# Office Action Summary

10/733,260

TAKAYAMA ET AL.

### **DETAILED ACTION**

**FIG. 5**

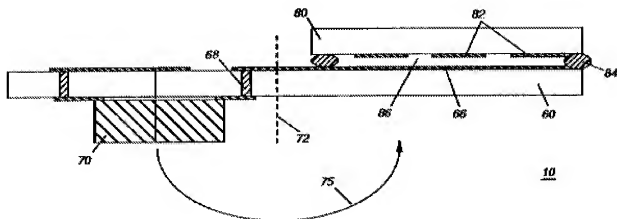
7. As for claims 1 – 2, Arledge discloses (Col. 3, lines 7 - 37) and shows in Fig. 5 a flexible LCD with integrated driver circuit comprising:

- a. a substrate (60) having a contact hole (where the conductive via (66) is preset);
- b. a liquid crystal display device (86) equipped on one side of the substrate; and
- c. a thin film integrated circuit (70) equipped on the other side of the substrate, wherein the display device is electrically connected to the thin film integrated circuit through the contact hole (68).

8. Arledge fails to disclose the limitation of each of the display device and the thin film integrated circuit comprising a polycrystalline semiconductor film.

20. As for claims 4 – 5, 7 – 8, 10, and 12, Arledge discloses (Col. 3, lines 7 - 37) and shows in Fig. 5 a flexible LCD with integrated driver circuit comprising:

- h. a substrate (60) having a contact hole (where the conductive via (68) is preset);
- i. a display device (86) equipped on one side of the substrate; and
- j. a thin film integrated circuit (70) equipped on the other side of the substrate, wherein the display device is electrically connected to the thin film integrated circuit through the contact hole (68) making it an active matrix type device since the IC is a driving IC.

21. Arledge fails to disclose the limitation of each of the display device and the thin film integrated circuit comprising a polycrystalline semiconductor film.

FIG. 4

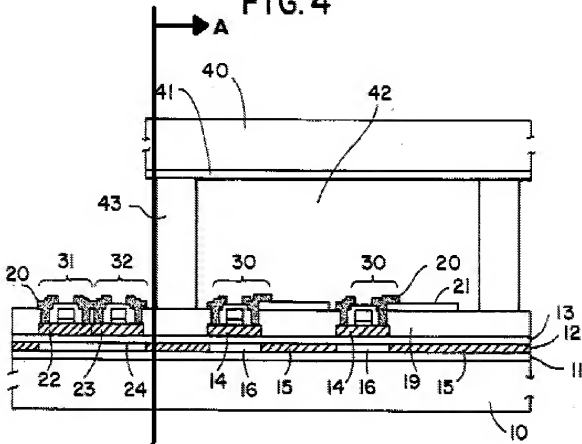
9. Kusumoto discloses (Col. 7, lines 33 – 58, Col. 4, line 10 – 20) and shows in Fig. 4 a LCD display (A) with a peripheral driving circuit (31, 32) where both use a polycrystalline semiconductor layer (14, 22, 24) on the construction.

10. Kusumoto is evidence that ordinary workers in the art would find a reason, suggestion or motivation to use a polycrystalline semiconductor layer in the construction of both the LCD and the IC driving circuit.

11. Therefore, it would have been obvious to one of ordinary skill in the art at the time of the invention was made to modify Arledge by using polycrystalline semiconductor layer in the construction of both the LCD and the IC driving circuit for

22. Kusumoto discloses (Col. 7, lines 33 – 58, Col. 4, line 10 – 20) and shows in Fig. 4 a LCD display (A) with a peripheral driving circuit (31, 32) where both use a polycrystalline semiconductor layer (14, 22, 24) on the construction.

**FIG. 8B**

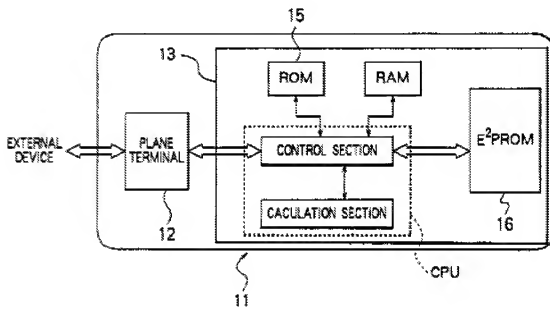
13. Iwasaki discloses (Col. 10, lines 27 - 34) and shows in Fig.8B an IC card (11) that comprises an IC (13) which includes a CPU and a Memory (16, 15).

14. Iwasaki is evidence that ordinary workers in the art would find a reason, suggestion or motivation to use an IC card that comprises an IC which includes a CPU and a Memory.

15. Therefore, it would have been obvious to one of ordinary skill in the art at the time of the invention was made to modify Arledge by using an IC card that comprises an

26. Iwasaki discloses (Col. 10, lines 27 - 34) and shows in Fig.8B an IC card (11) that comprises an IC (13) which includes a CPU and a Memory (16, 15).

**FIG. 8**

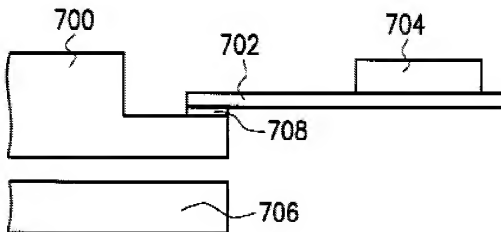
38. As for claim 16, Arledge in view of Kusumoto fail to disclose a use of adhesive agent.

39. Chen discloses (Col. 5, lines 60 – 64) and shows in Fig. 8 the use of an adhesive agent (708) to connect the LCD (700, 706) to the substrate (702).

40. Chen is evidence that ordinary workers in the art would find a reason, suggestion or motivation to use an adhesive agent (708) to connect the LCD (700, 706) to the substrate (702).

41. Therefore, it would have been obvious to one of ordinary skill in the art at the time of the invention was made to modify Arledge in view of Kusumoto by using an adhesive agent (708) to connect the LCD (700, 706) to the substrate (702) for such advantages as providing secure and stable connection between the display device and the driving circuit (Col. 2, lines 45 – 54).

50. Chen discloses (Col. 5, lines 60 – 64) and shows in Fig. 8 the use of an adhesive agent (708) to connect the LCD (700, 706) to the substrate (702).
